CHECK PRINT 1/9/04

rev 11/18/02 rhm/ GTP			
title Digital Optical Module Crystal			
Size	Document Number	sheet 3 of 14	Rev 12.0
Date: Wednesday, October 09, 2002 sheet 14 of 14

rev 11/19/02	rhm/glp	rev 12/11/02	rhm	repaired	gnd	symbol
Title Digital Optical Module Power Supply						
Size	Document Number					Rev
C	main_board_vsn4.1					sheet 4
Date: Wednesday, October 09, 2002	Sheet 13					of 14

Title: Digital Optical Module Memory			
* -DNL			
Size: D	Document Number: main_board_vsn4.1	Sheet: 7	Rev: 12.0
Date: Wednesday, October 09, 2002	Sheet: 10	of 14

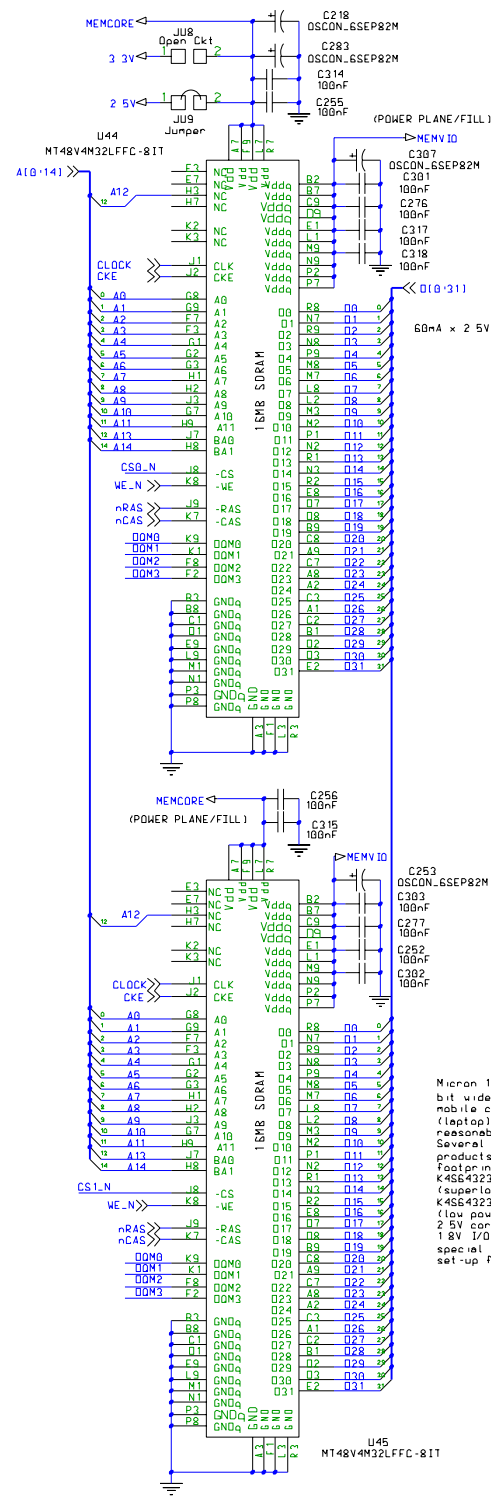
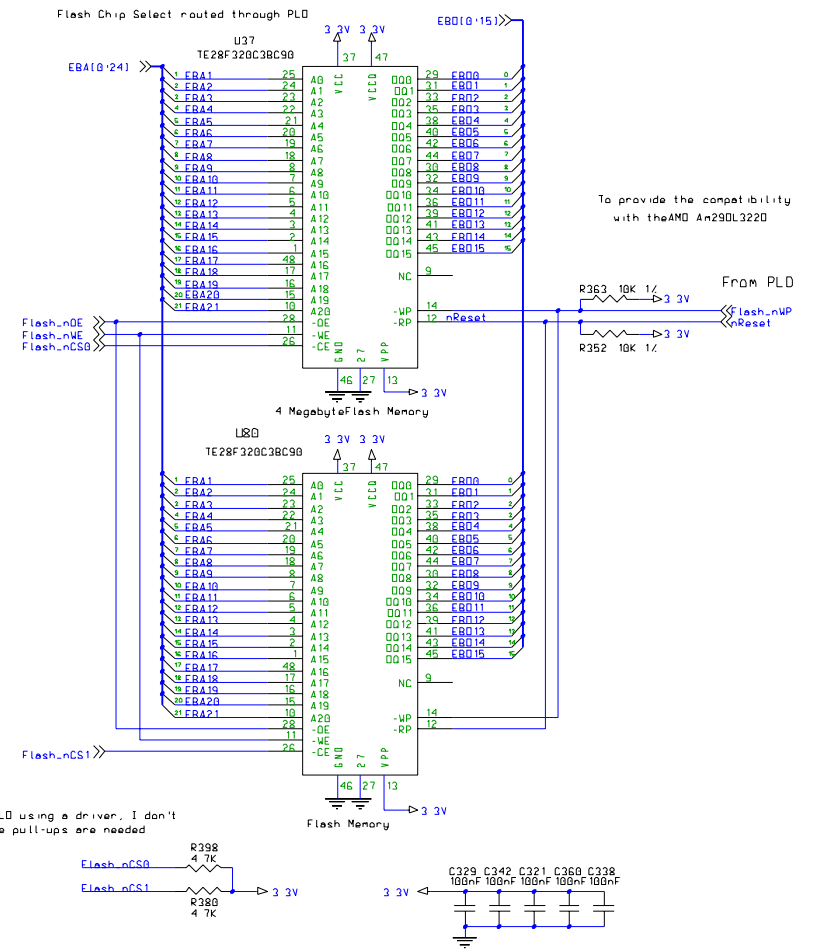
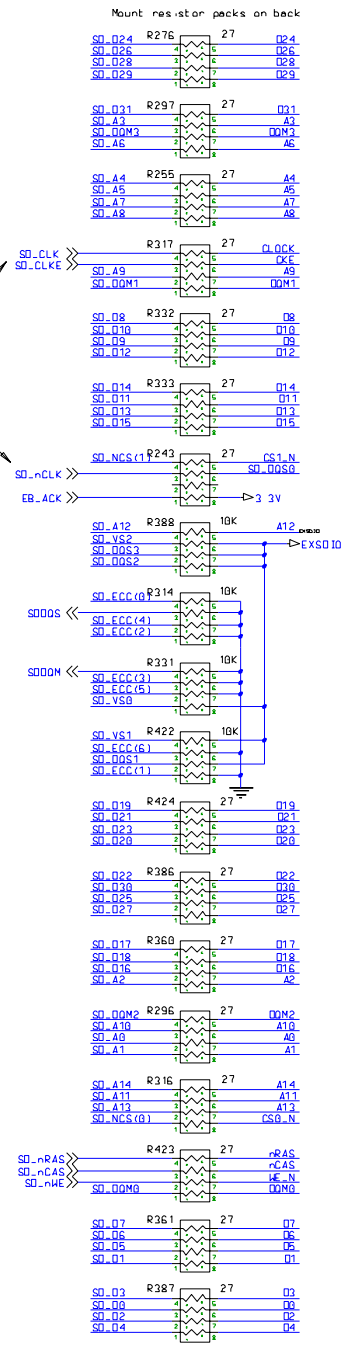
Micron 16 Megabyte 32 bit wide memory for mobile computers (laptop) has reasonable power. Several of the products have the same footprint. K4S64323LF-S(D)U15 (super low power -25C) 2.5V core, 1.8V I/O. K4S64323LF-S(D)P15 (low power -40C) 2.5V core, 1.8V I/O. 1.8V I/O requires special register set-up for CPU.

SD\_nCLK must make a loop of approx same length as SD\_CLK to match timing. See HW Ref Manual

With the PLD using a driver, I don't think these pull-ups are needed

rhm 9/24 changed to EXSDIO for fixed resistors

Title			
Digital Optical Module Local Coincidence			
Size	Document Number	Sheet	Rev
C	main_board_vsn4.1	8	12.0
Date	Wednesday, October 09, 2002		Sheet 9 of 14

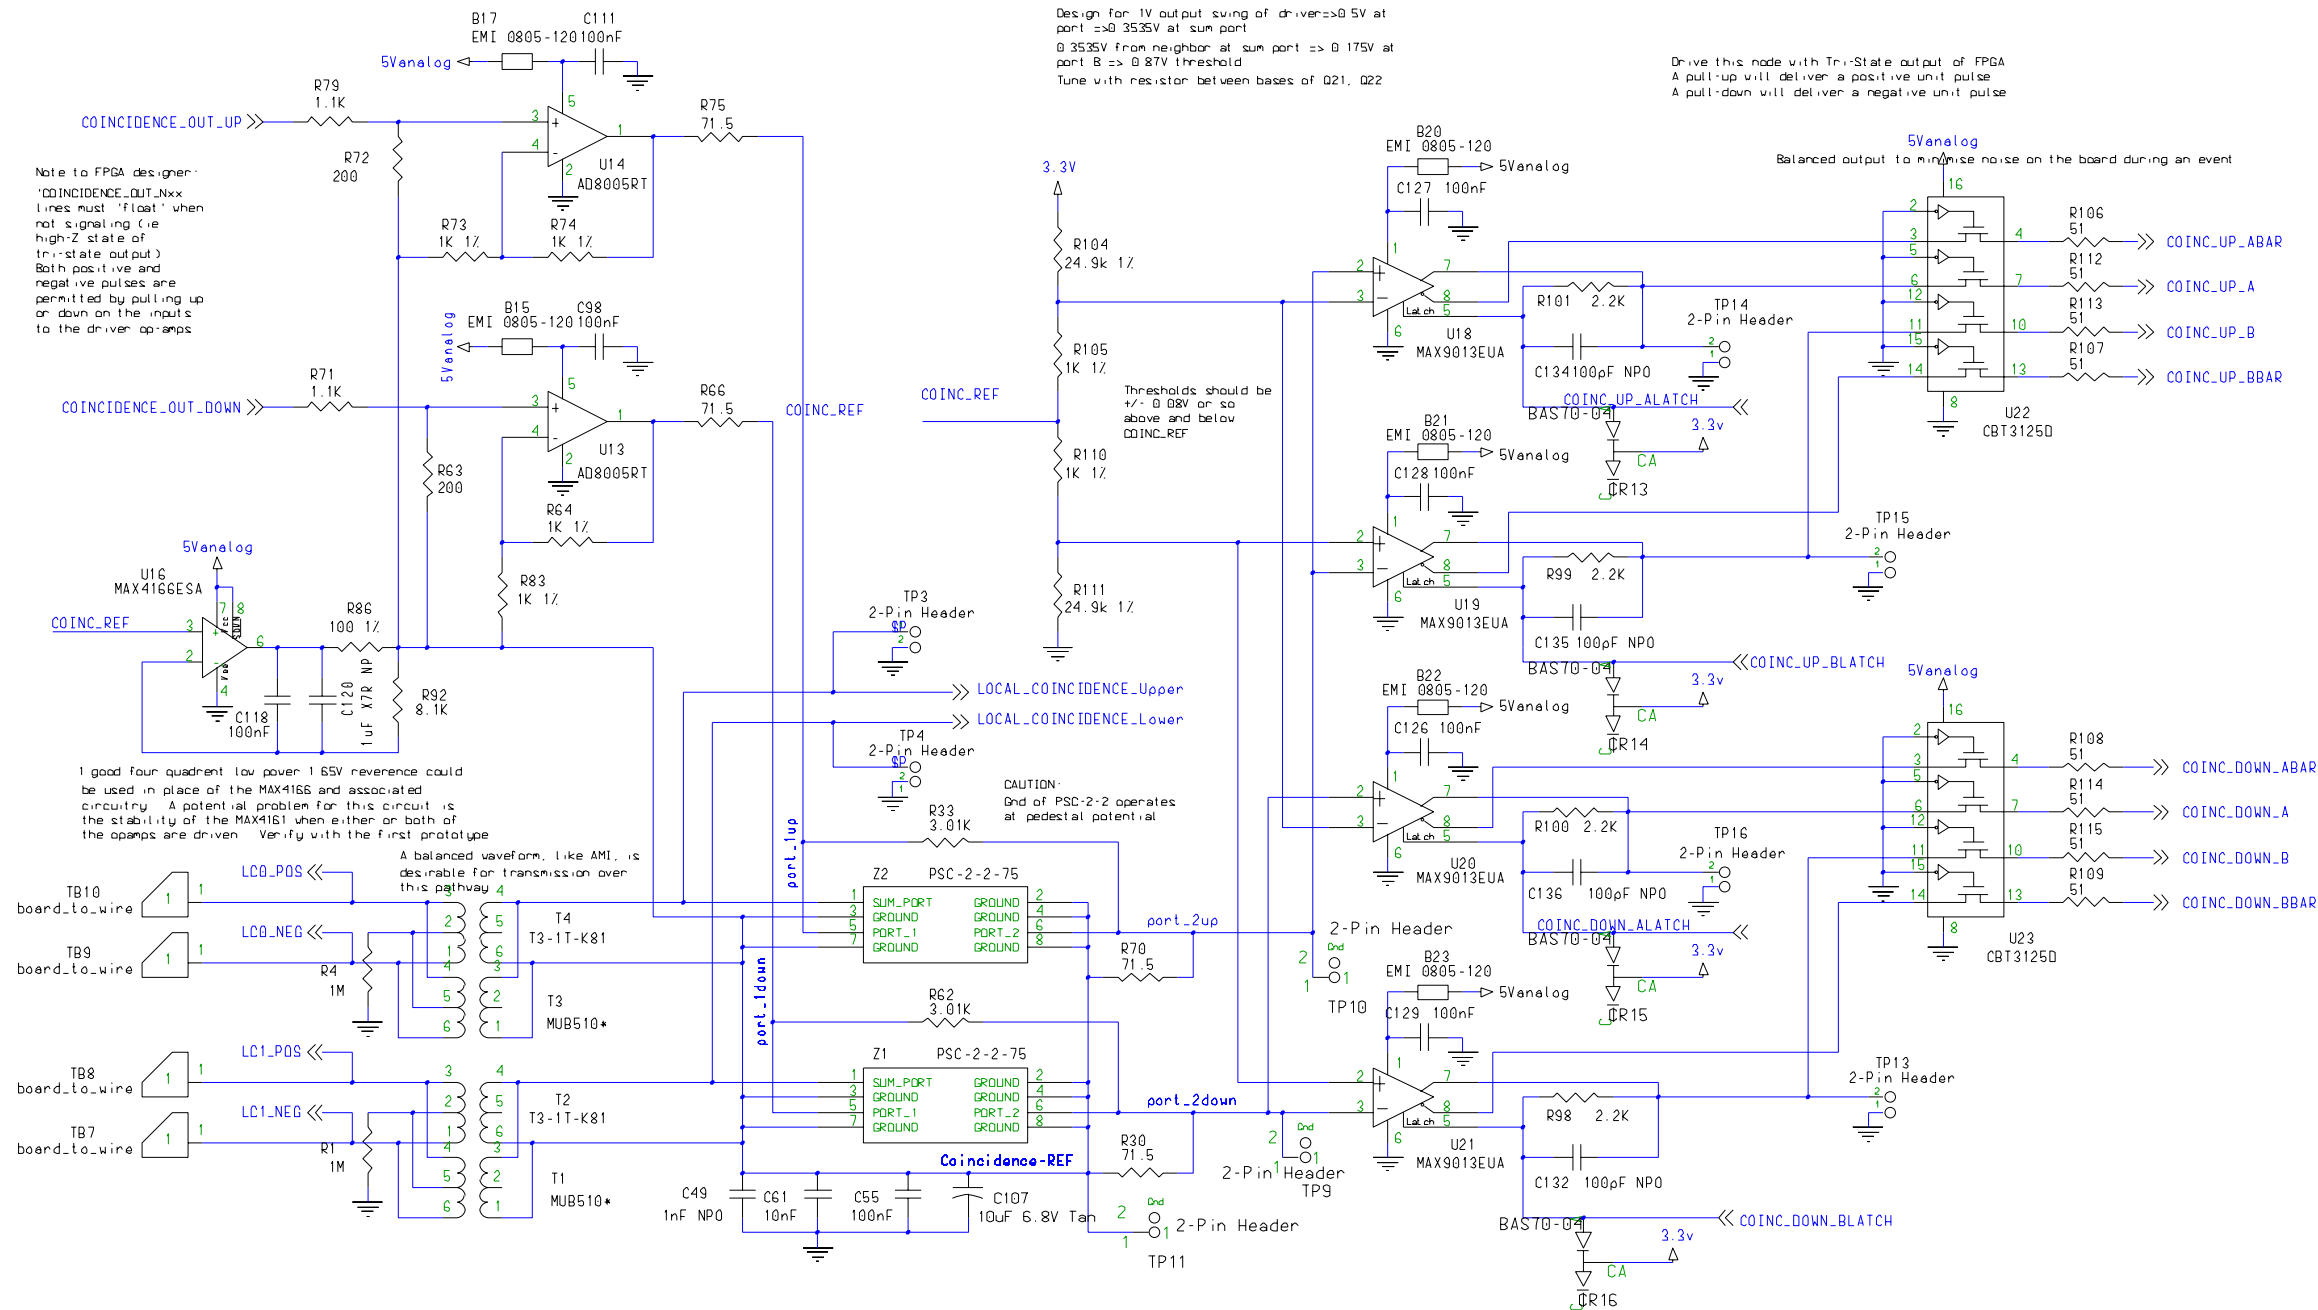
Note to FPGA designer:  
 \*COINCIDENCE\_OUT\_Nxx  
 lines must 'float' when  
 not signaling (i.e.  
 high-Z state of  
 tri-state output)  
 Both positive and  
 negative pulses are  
 permitted by pulling up  
 or down on the inputs  
 to the driver op-amps

1 good four quadrant low power 1.65V reference could  
 be used in place of the MAX4166 and associated  
 circuitry. A potential problem for this circuit is  
 the stability of the MAX4166 when either or both of  
 the opamps are driven. Verify with the first prototype

A balanced waveform, like AMI, is  
 desirable for transmission over  
 this pathway

Design for 1V output swing of drivers => 0.5V at  
 port1 => 0.3535V at sum port  
 0.3535V from neighbor at sum port => 0.175V at  
 port B => 0.87V threshold  
 Tune with resistor between bases of Q21, Q22

Thresholds should be  
 +/- 0.08V or so  
 above and below  
 COINC\_REF

CAUTION:  
 Gnd of PSC-2-2 operates  
 at pedestal potential

Title Off-Board Subsystems			
Size C	Document Number main_board_vsn4.1	Sheet 9	Rev 12.0
Date: Wednesday, October 09, 2002	Sheet 8	of 14

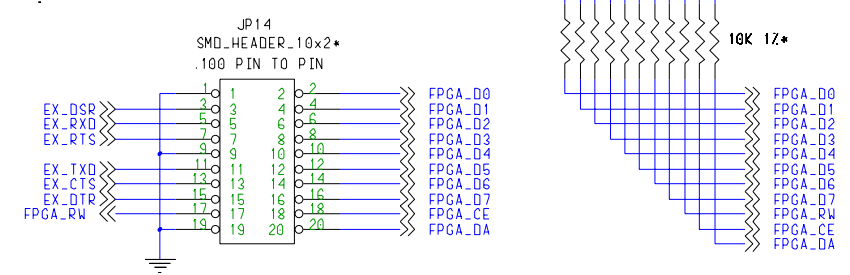
9/24 rhm change flsher pin 32 to +5v and pin 23 to 3.3V

Should be STMM-112-02-S-D for EMCO base  
Should be STMM-110-02-S-D for ISEG base  
(24 pin for EMCO, 20 pin for ISEG)

Title		GTP/JL/DRN/HY	
Digital Optical Module Analog Front End			
Size	Document Number	Rev	
0	no_n_board_vsn4.1	Sheet 13	12.0
Date:	Wednesday, October 09, 2002	Sheet	4 of 14

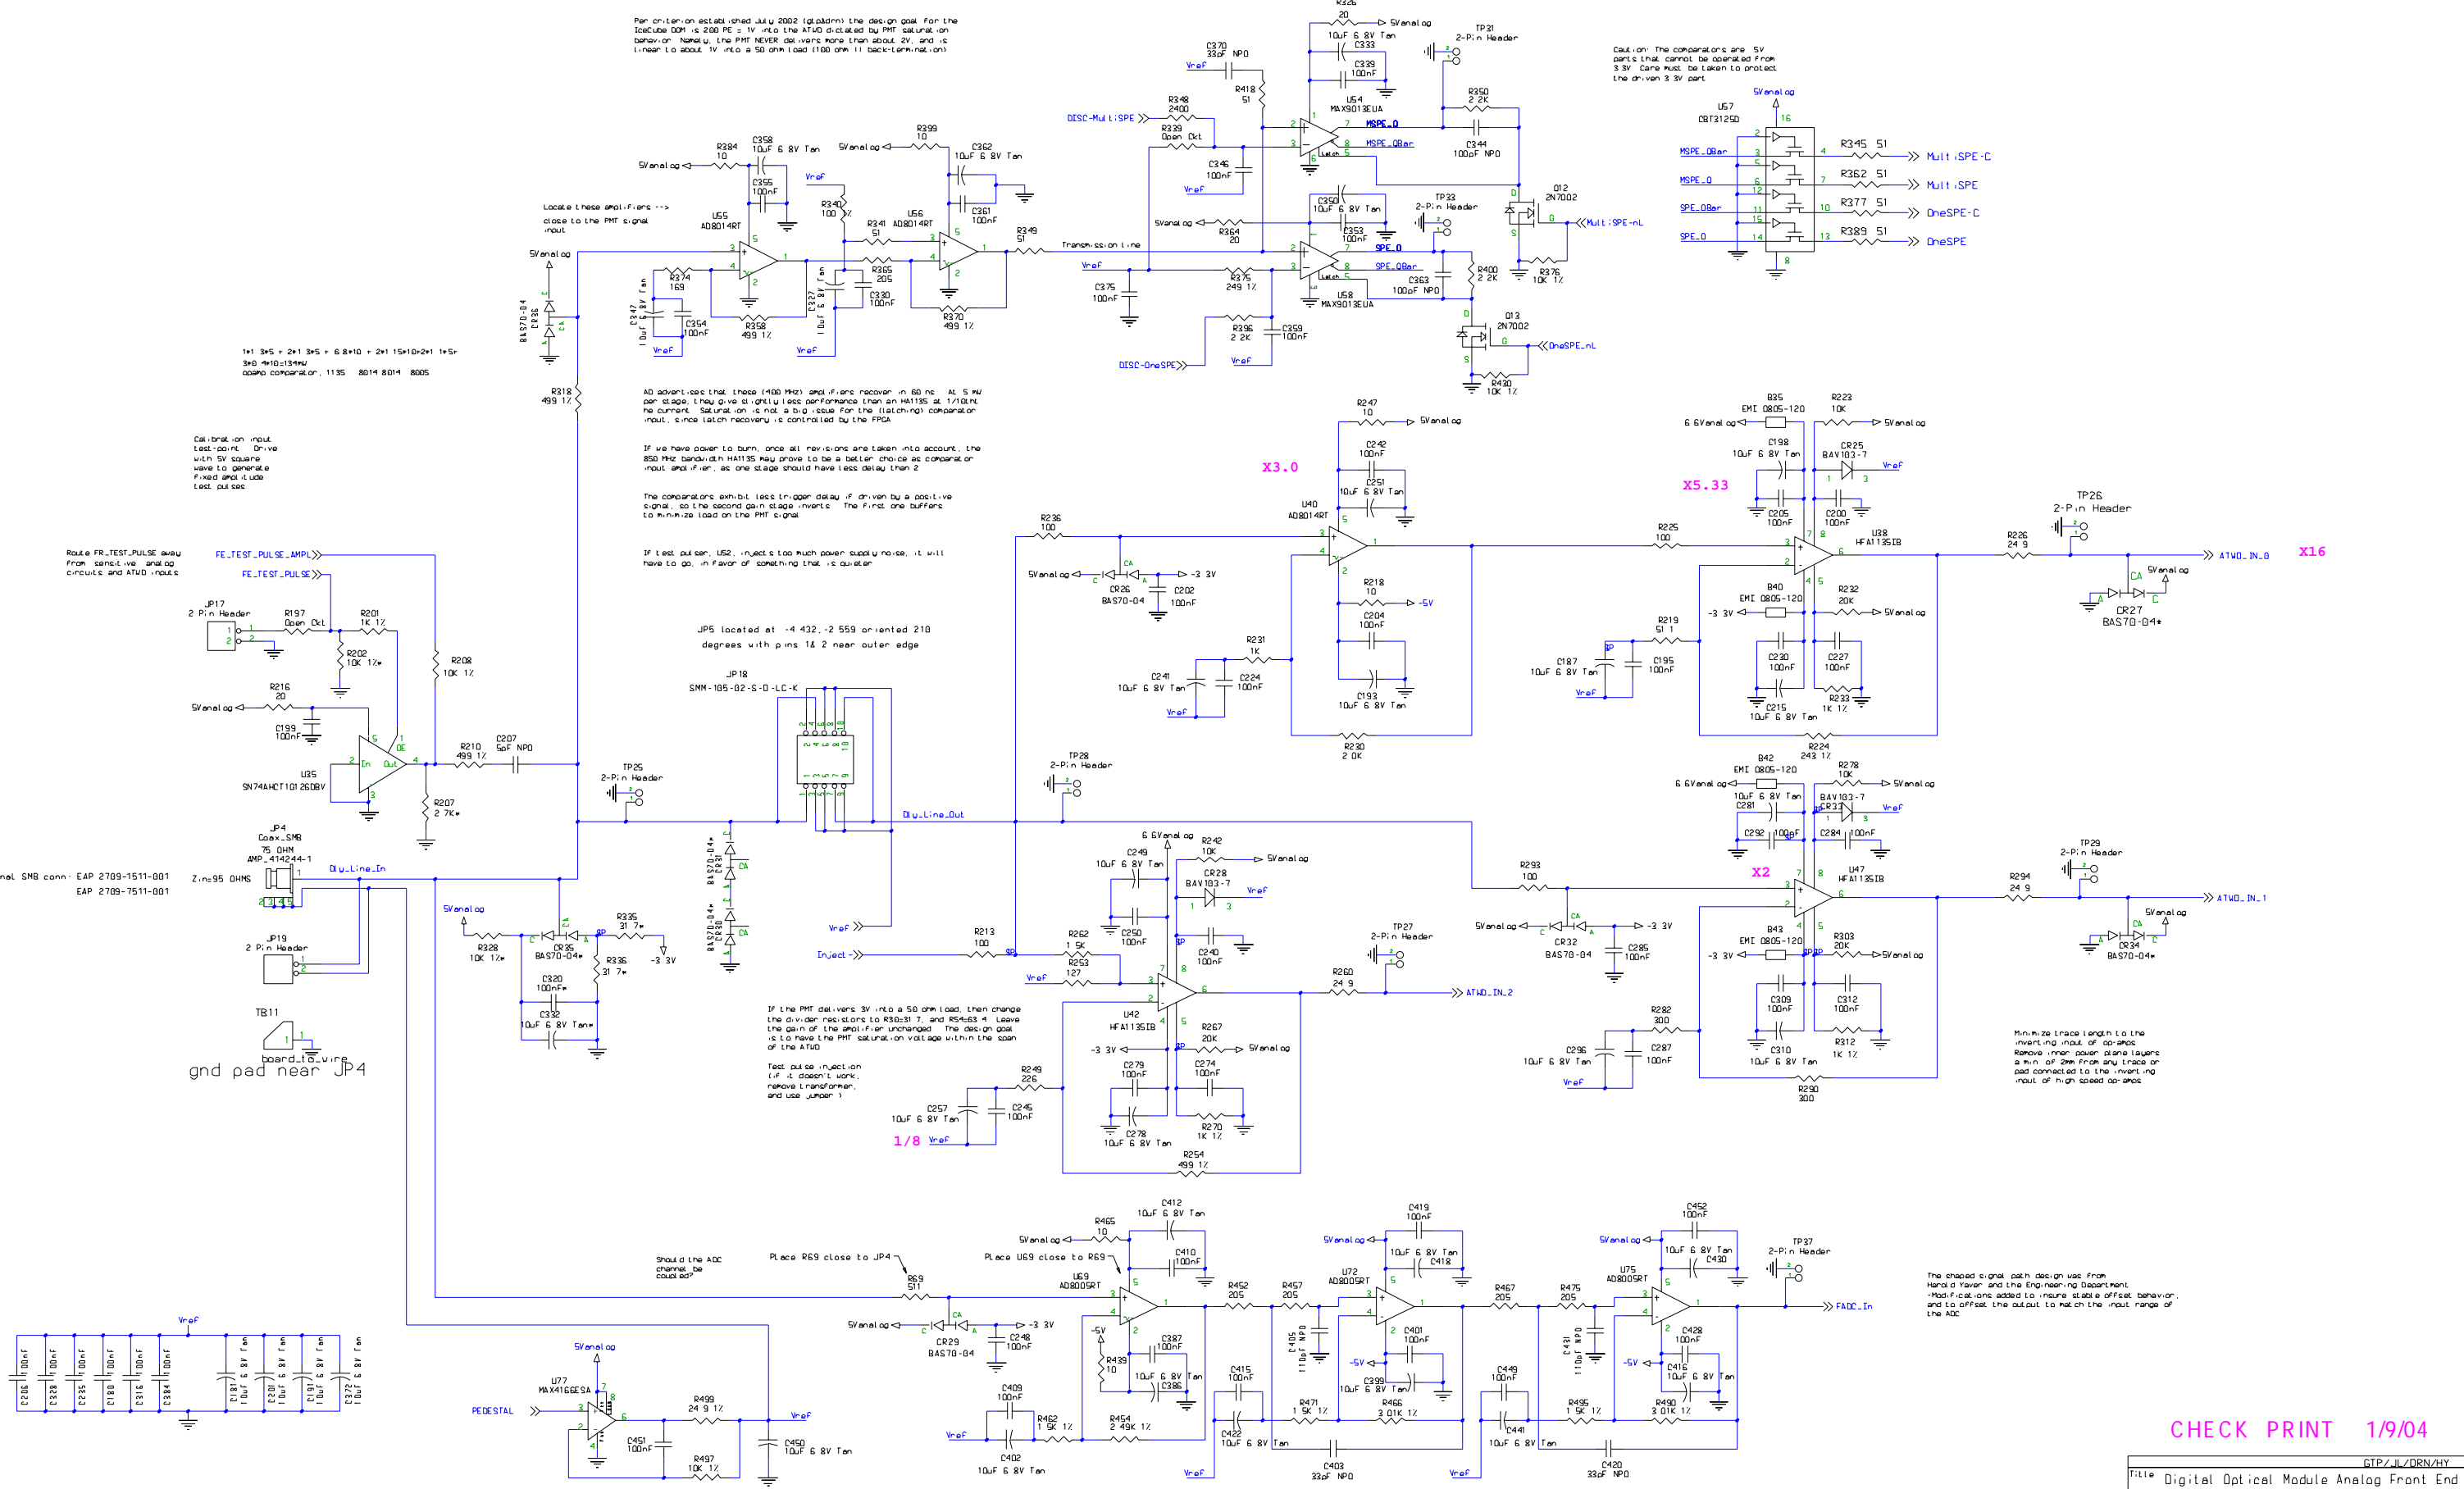
If the FE\_TEST\_PULSE line injects objectionable noise into the front, then perhaps that could be mitigated by making a 1:1 drive differentially -> ATWDTrigger\_0

Caution: The comparators are 5V parts that cannot be operated from 3.3V. Care must be taken to protect the driven 3.3V part.

AD advertises that these 1400 MHz amplifiers recover in 60 ns. At 5 MHz per stage, they give slightly less performance than an HA1135 at 1/10th the current. Saturation is not a big issue for the (latching) comparator input, since latch recovery is controlled by the FPGA.

If we have power to burn, once all provisions are taken into account, the 850 MHz bandwidth HA1135 may prove to be a better choice as comparator input amplifier, as one stage should have less delay than 2.

If test-out, U52, injects too much power supply noise, it will have to go in favor of something that is quieter.

If the PMT delivers 3V into a 50 ohm load, then change the divider resistors to R30x31.7, and R5x63.4. Leave the gain of the amplifier unchanged. The design goal is to have the PMT saturation voltage within the span of the ATU.

Test pulse injection (if it doesn't work, remove transformer, and use jumper)

Should the ADC channel be coupled?

Place R69 close to JP4

Place U69 close to R69

Title			Digital Optical Module AD/DA
Size	Document Number	Sheet	Rev
C	main_board_vsn4.1	14	12.0
Date:	Wednesday, October 09, 2002	Sheet	3 of 14

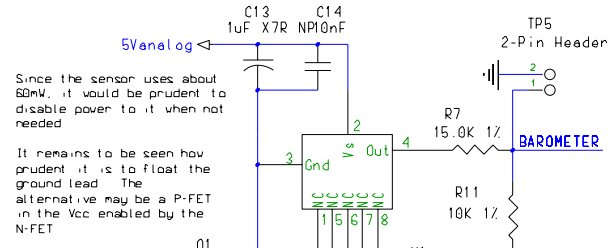
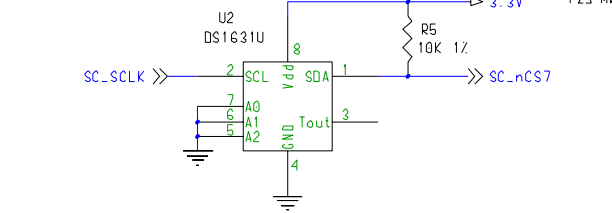
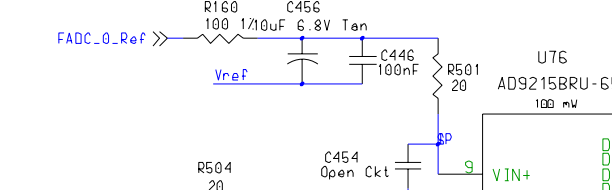
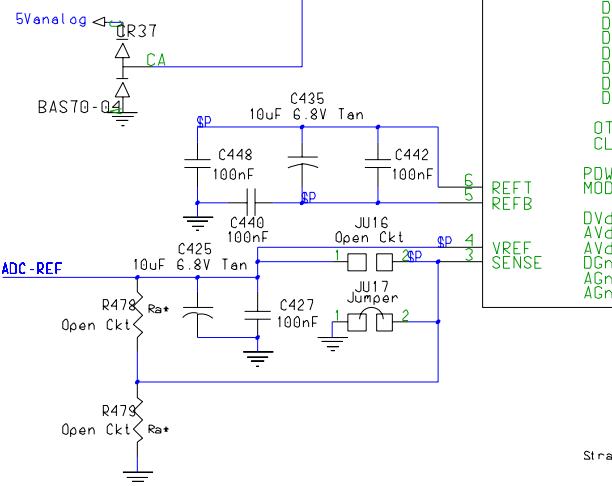
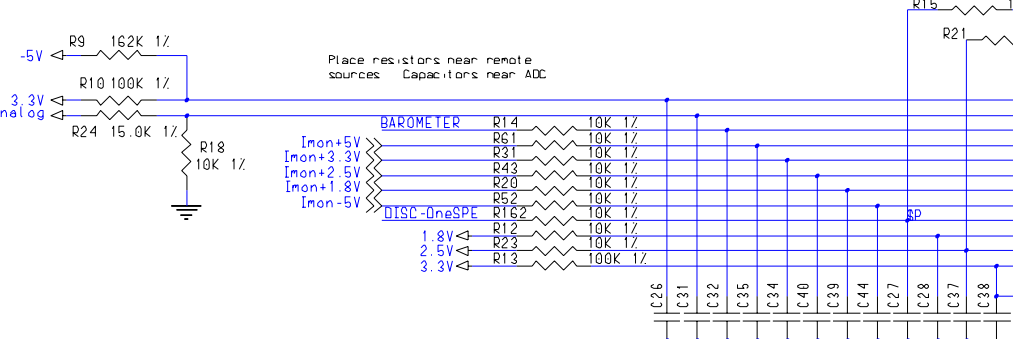
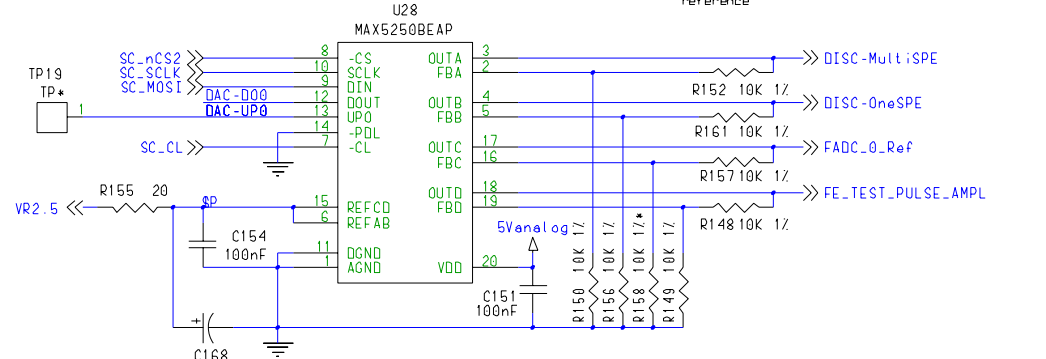
Since the sensor uses about 60mV, it would be prudent to disable power to it when not needed.

It remains to be seen how prudent it is to float the ground lead. The alternative may be a P-FET in the Vcc enabled by the N-FET.

Let's just assume that if +5 is gone, we're dead. The 5V CPU supervisory chip input will cause a reboot below about 4.750V.

Note that this ADC is differential input Amplifier and shaper stages are DC coupled. The "bottom" of the span depends on the setting of the ATVD pedestal voltage. I.e. Pedestal for the ADC = Pedestal for the ATVD. V+ in must be set to (Vpedestal - (span/2)) volts, or a few mV lower.

A 10uF Tantalum capacitor is needed on U4-1 to insure stability. gtp 4/13/99

If we can use the 2.5V reference output of the ADC, then we can eliminate the TLE2425 reference chip.
